Appendix A – Response to Wollongong City Council Submission

A detailed response to the matters raised in the submission of Wollongong City Council (**Council**) is provided in the table below.

Figure 1 Grey-headed Flying-fox Camp (Figure 17 of Wollongong DCP Chapter D19 Former Corimal Coke Works Site)

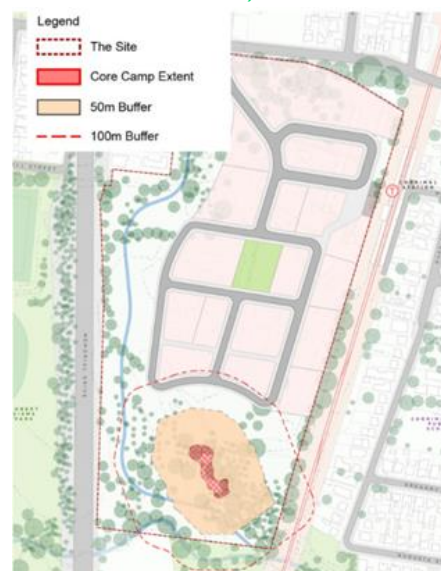
The southern park is to be located outside of the 50m buffer to the Grey Headed Flying Fox (GHFF) Camp as depicted in the DCP. There is currently

significant encroachment which impacts on both the GHFF and enjoyment and wellbeing of park users.

Section 5.13 of Chapter D19 was developed through the planning proposal process and supported by detailed investigation of the GHFF camp. The

objectives of the Southern Recreation Park include providing a transition zone between the GHFF core camp and future residential development. This objective recognises that the park is intended to function as a managed interface.

Figures contained within the DCP, including Figure 17 (Grey-headed Flying-fox Camp), clearly identify the GHFF core camp extent as well as 50-metre and 100-metre buffers. Importantly, the indicative location of the Southern Recreation Park is shown within the buffer area. This confirms that the presence of the park within the 50-metre buffer was anticipated, assessed and deliberately incorporated into the site-specific planning framework.

The DCP does not contain any provision that prohibits construction of the Southern Park within the GHFF buffer zones. Nor does it require public open space to be excluded from the 50-metre buffer. To the contrary, the park's location within this area directly implements the DCP's stated objective to create a transitional landscape between sensitive ecological values and urban development.

Council's suggestion that the park must be located entirely outside the 50-metre buffer is inconsistent with the adopted master planning outcomes and the DCP controls.

Accordingly, the proposed location of the Southern Park is consistent with the objectives, mapping and intent of Chapter D19 of Wollongong DCP 2009, and there is no planning basis to require its exclusion from the 50-metre GHFF buffer.
